Addendum No. 2

Four Rivers Sanitation Authority

BNR Improvements - Aeration Basin Modifications

Capital Project No. 2304

00-E-301

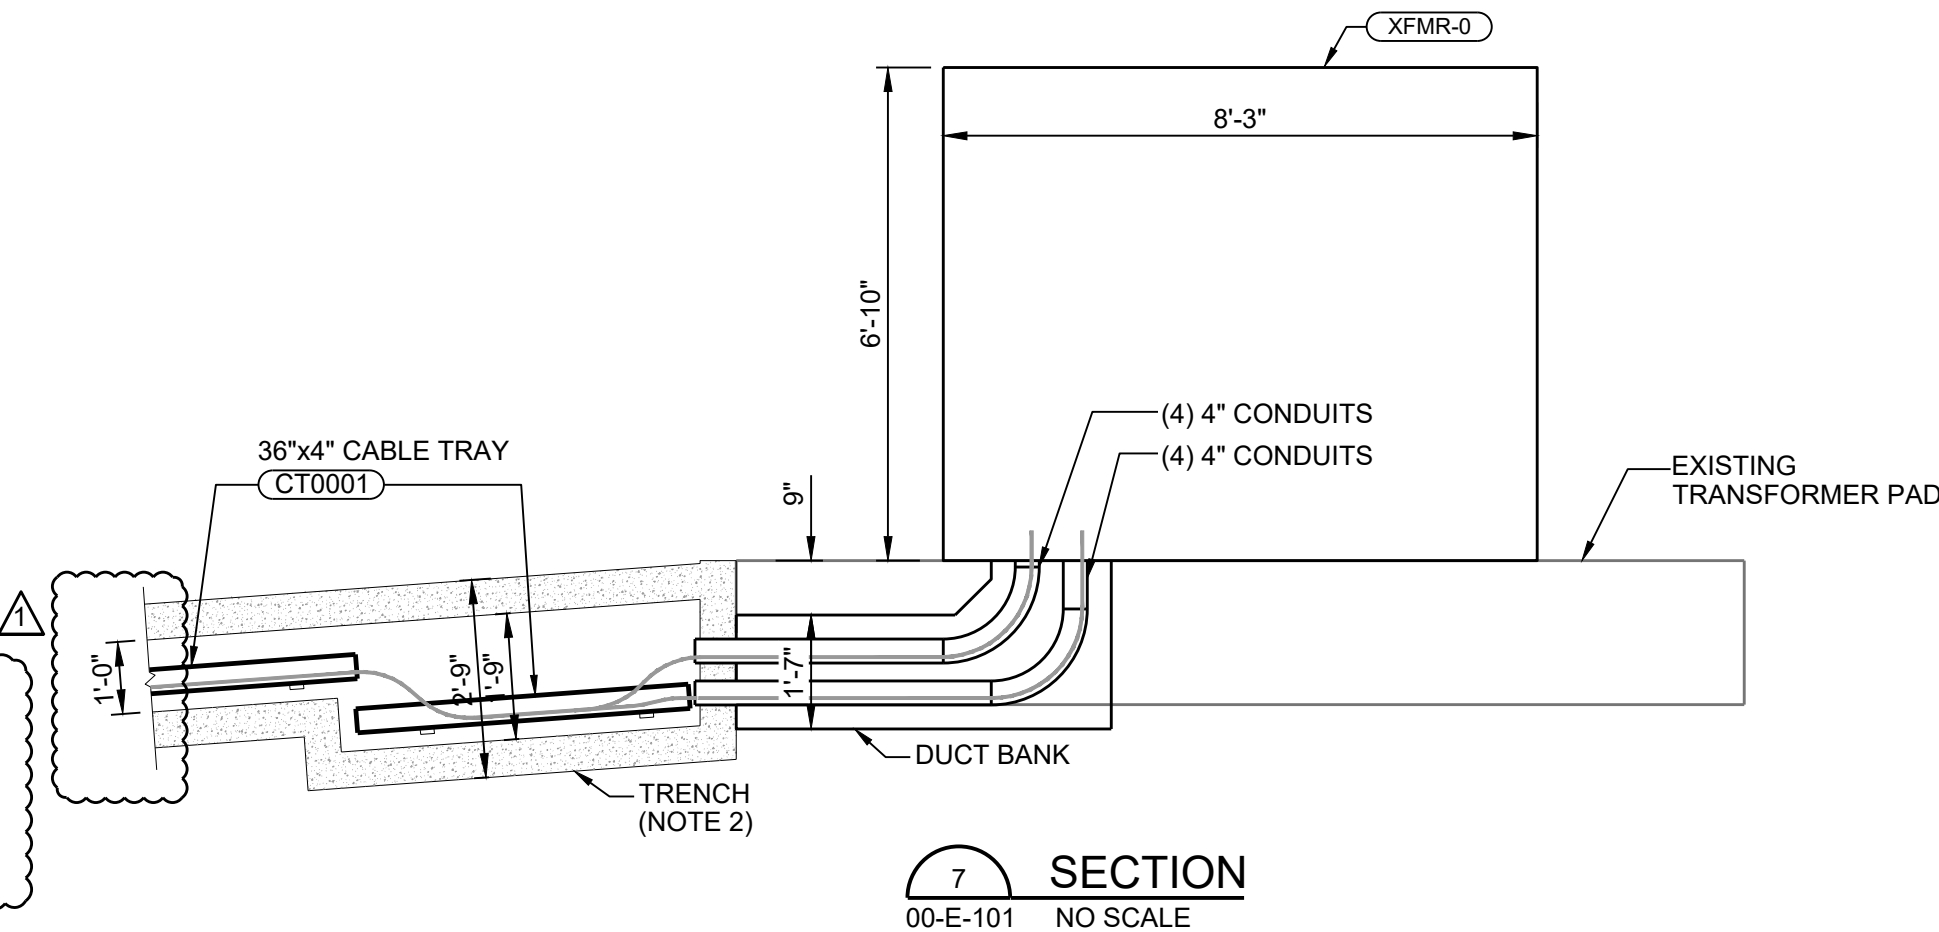
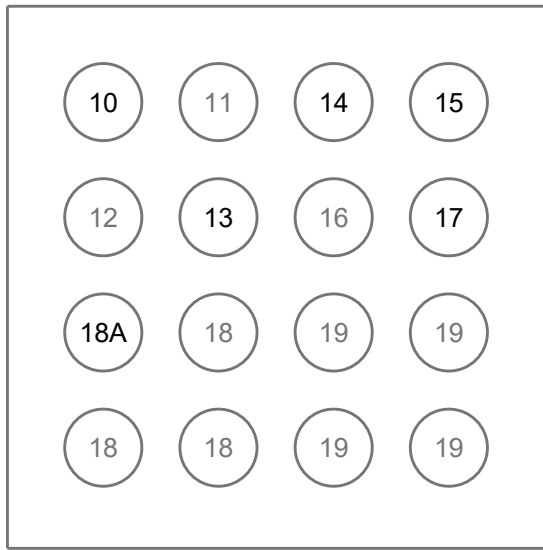
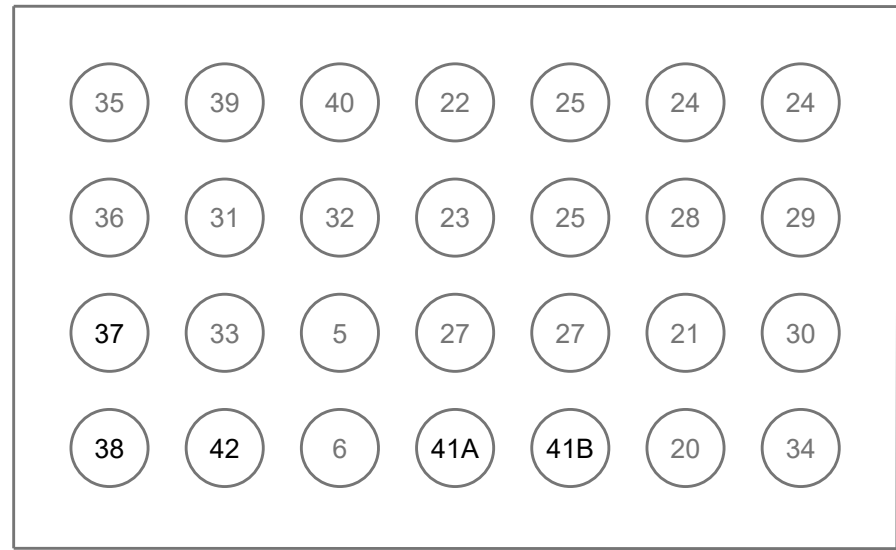
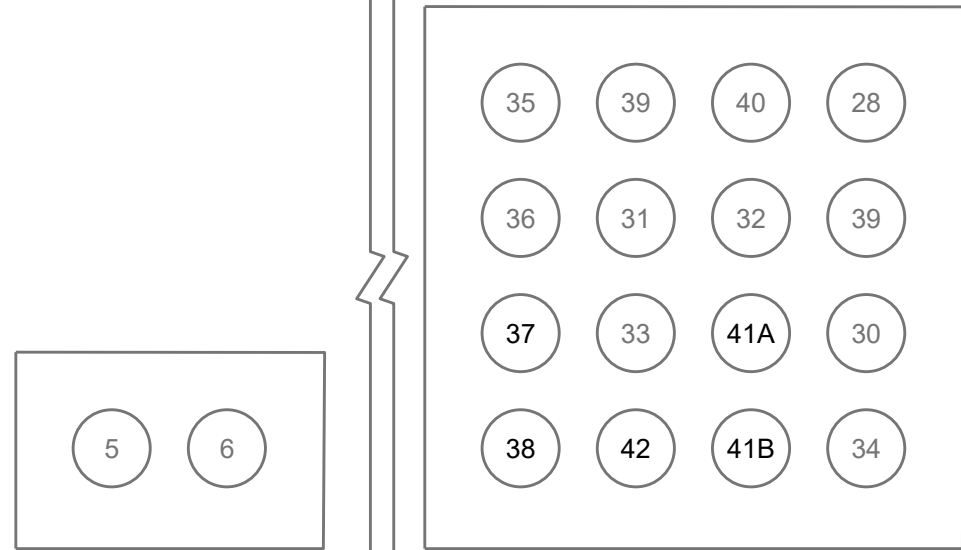
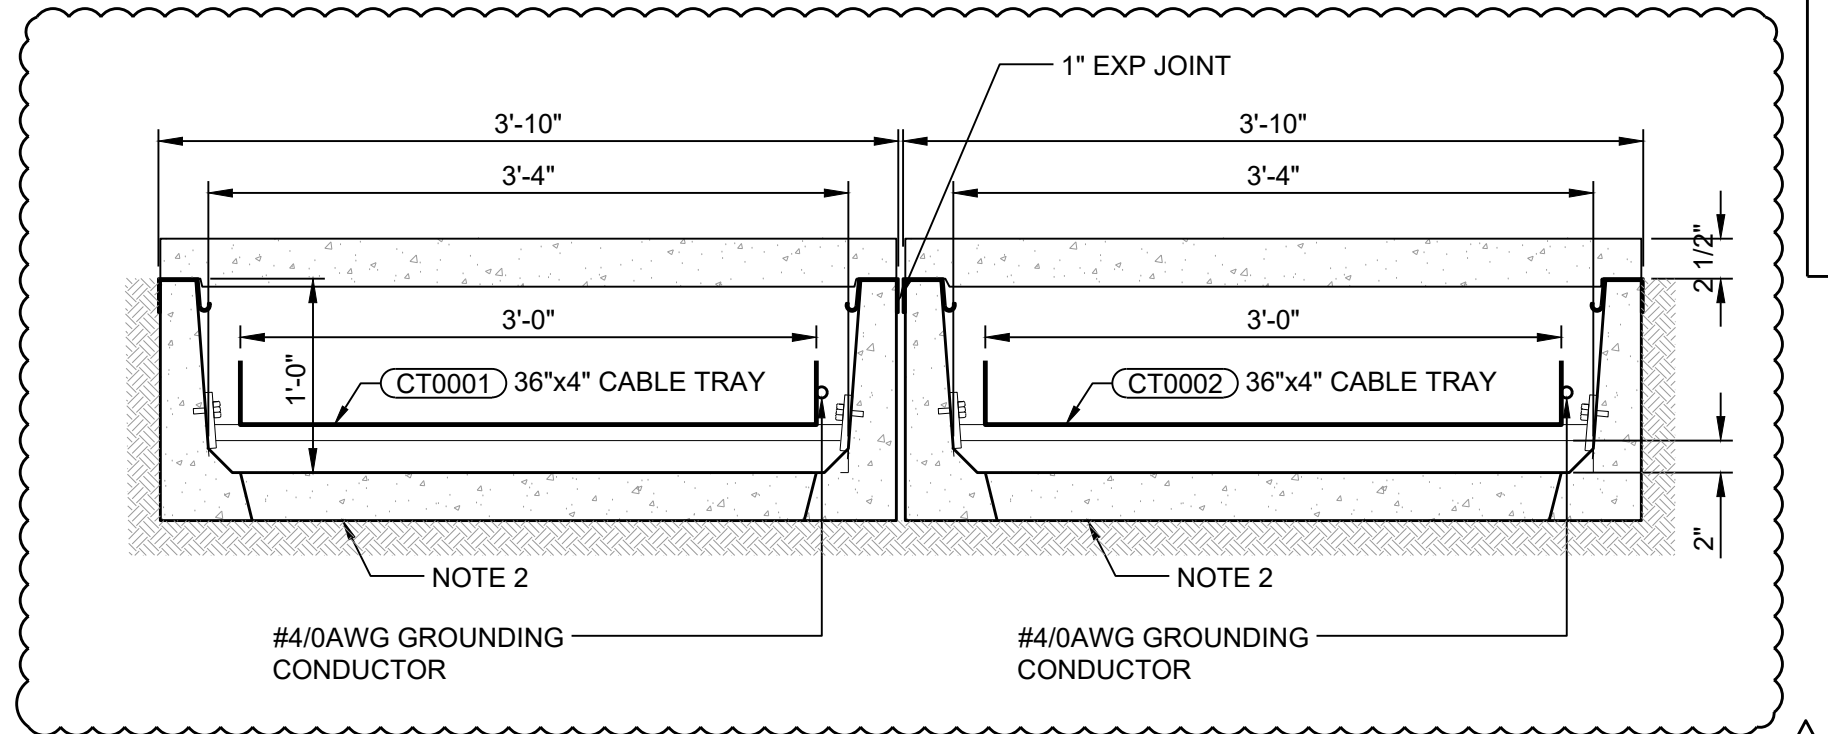
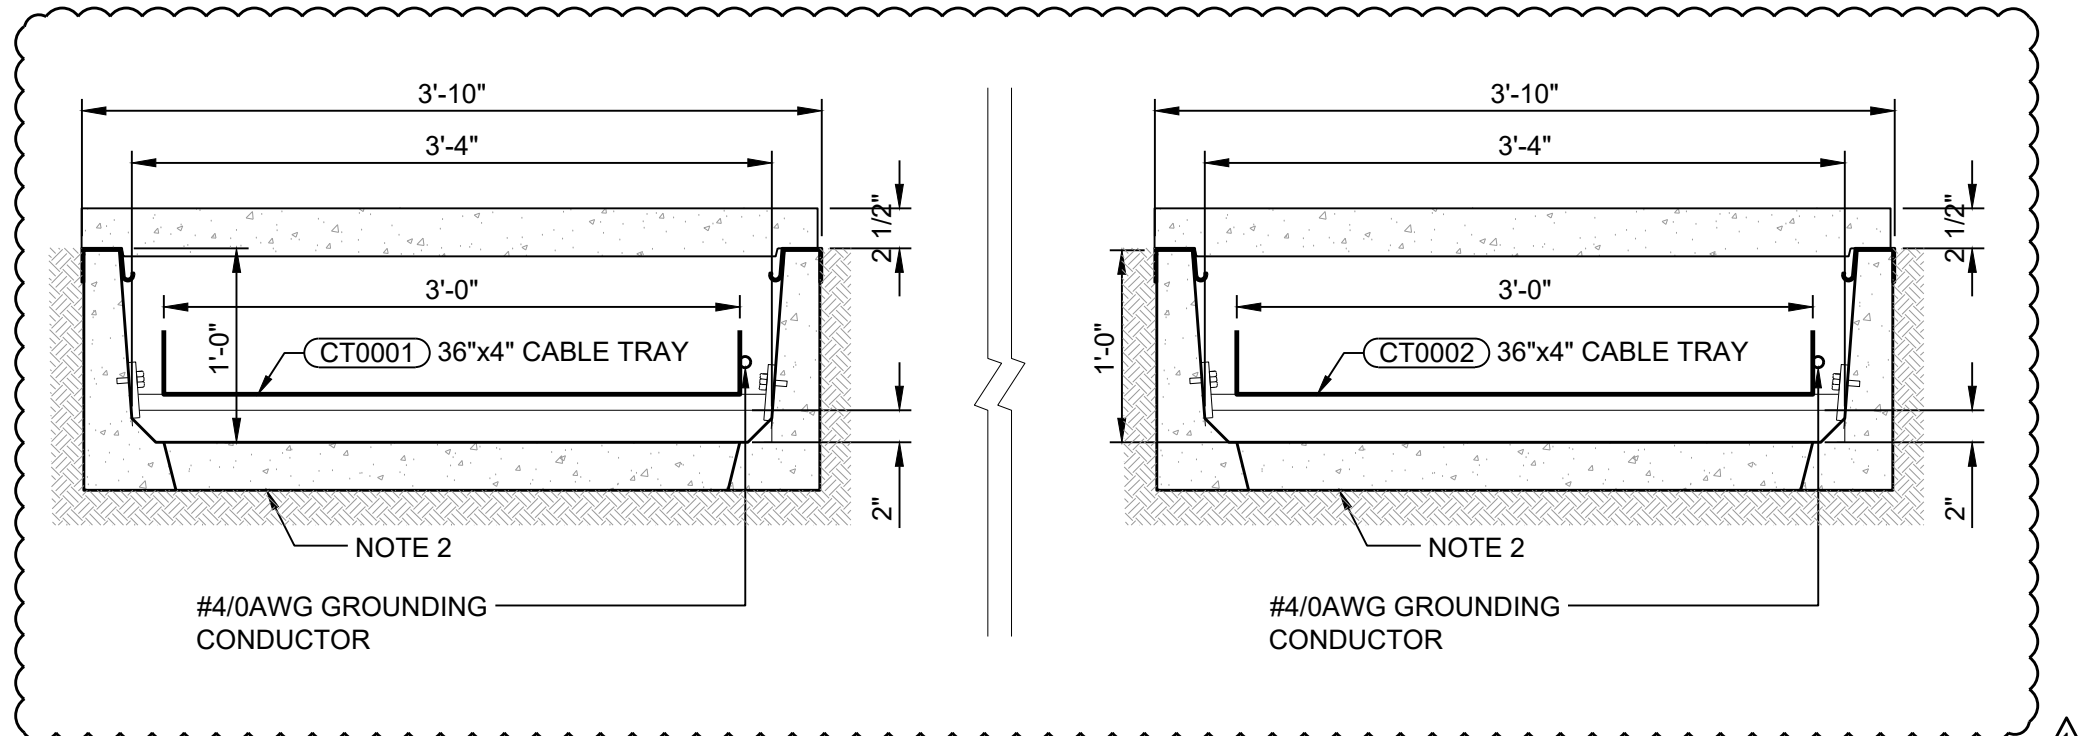
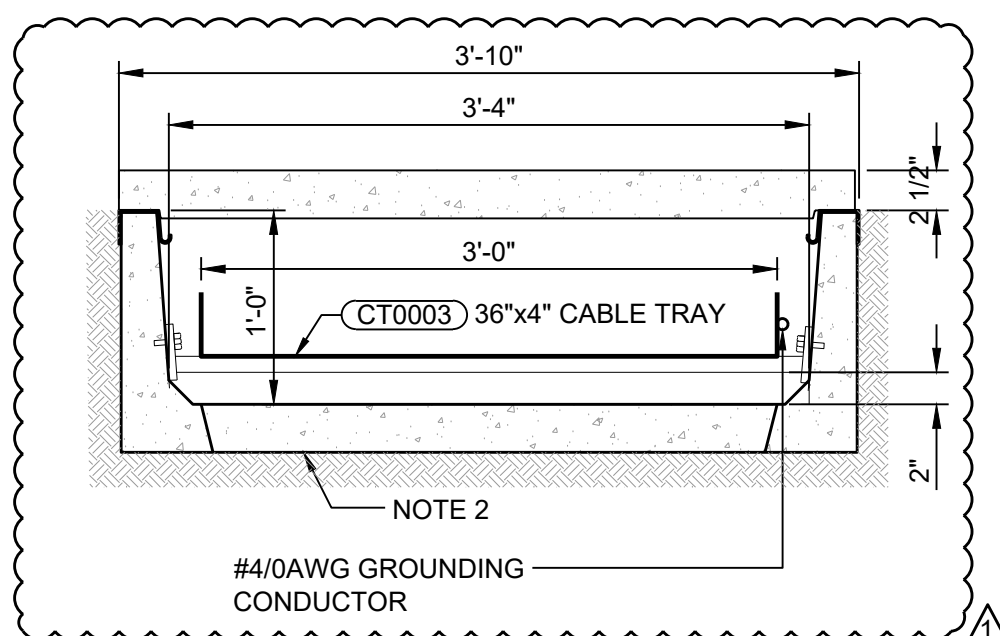
6. Drawing 00-E-301, Sheet 33 of 113:

- a. Replace drawing 00-E-301 with drawing 00-E-301, attached to this addendum.
